Access Compliance Report Public Rights-of-Way (Curb Ramps)

Main Street: HEWES_ST Cross Street: VINE_ST Location: SW

ADA ID: RPAT210929092610 Ramp Type: Type 4 - Parallel Initial Pass/Fail: Pass Overall Compliance: No Severity Score: 6

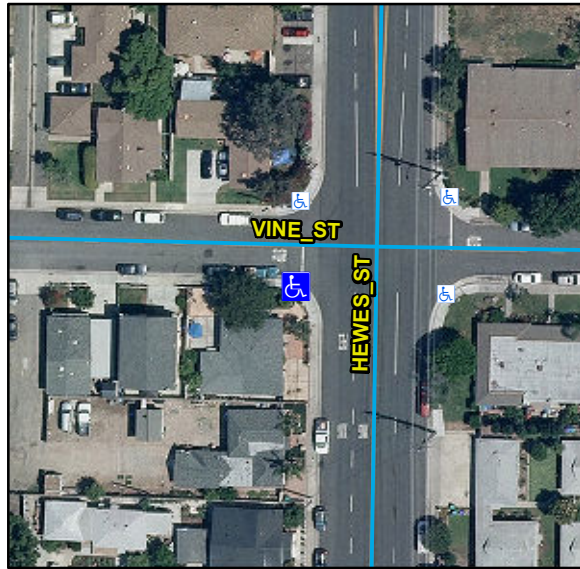
Compliance	Description	Data	Compliance	Description	Data
N/A	Ramp Length LT (in)	106	N/A	Ramp Length RT (in)	72
Yes	Ramp Width LT (in)	48	Yes	Ramp Width RT (in)	48
Yes	Ramp Run Slope LT (%)	6.7	Yes	Ramp Run Slope RT (%)	1.2
Yes	Ramp Cross Slope LT (%)	0.5	Yes	Ramp Cross Slope RT (%)	0.9
N/A	Landing Present	Yes	Yes	DWS Provided	Yes
N/A	Landing Length (in)	48	Yes	DWS Contrast	Yes
Yes	Landing Width (in)	48	Yes	DWS Length (in)	36
Yes	Landing Run Slope (%)	0.9	Yes	DWS Full Width	Yes
No	Landing Cross Slope (%)	4.1		DWS Offset Type	Single
N/A	Landing Movement Obstructed?	No	Yes	DWS Offset Left (in)	0
	Landing Movement Type	Curb	Yes	DWS Offset Right (in)	N/A
N/A	Landing Shared	No			
N/A	Clear Space	Yes			
N/A	Clear Space To Crosswalk (in)	48			
N/A	Marked Crosswalk 1	No	N/A	Marked Crosswalk 2	No
	Crossing 1 Direction	E		Crossing 2 Direction	N
	Marked Crosswalk 1 Width (in)	N/A		Marked Crosswalk 2 Width (in)	N/A
N/A	Ramp Inside Crosswalk 1	N/A	N/A	Ramp Inside Crosswalk 2	N/A

Crossing 1 Slope (%)	6.7		Crossing 2 Slope (%)	3.3
	Crossing 1 Cross Slope (%)	0.7		Crossing 2 Cross Slope (%)	5.1
Yes	Gutter Ponding	No	Yes	Curb Slope	6.6
Yes	Gutter Lip Height (in)	0		Road Run Slope (%)	3.4
No	Gutter Run Slope (%)	5.9		Road Cross Slope (%)	5.7
No	Gutter Cross Slope (%)	4.9	Yes	Perpendicular Joint Present	Yes
Yes	Overall Surface Condition	Acceptable			
	Cross Gutter Present?	No		Spandrel Present?	No
	Replace Cross Gutter?	N/A		Replace Spandrel?	N/A

Remove & Replace Landing. Remove & Replace Gutter.

R304.5.3, R304.5.4, STD 1115
